Docket No. 50-447

Subject: Request for Additional Information Regarding the General Electric Application for an FDA for a Standardized Nuclear Island (GESSAR-II)

Round 1 Questions on GESSAR-IIDocket No. STN 50-447

Diagram 2A

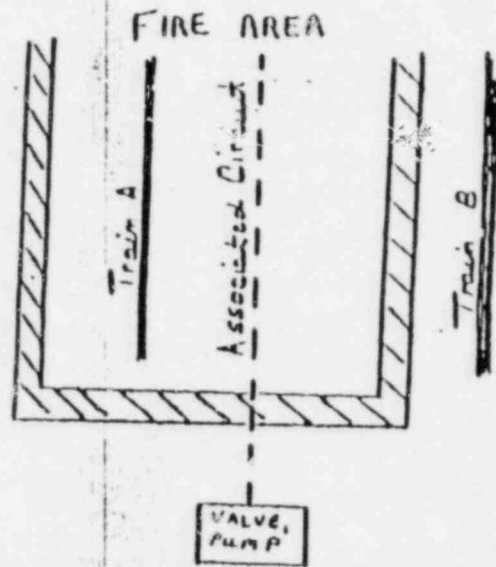
EXAMPLES OF ASSOCIATED CIRCUITS OF CONCERN

Diagram 2B

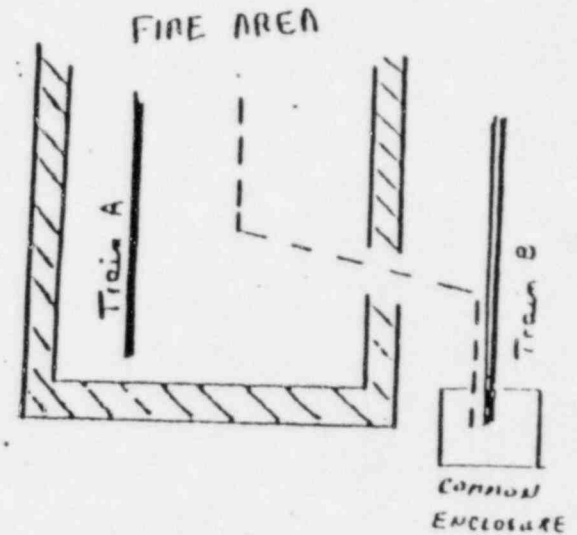
Equipment where spurious operations could affect shutdown
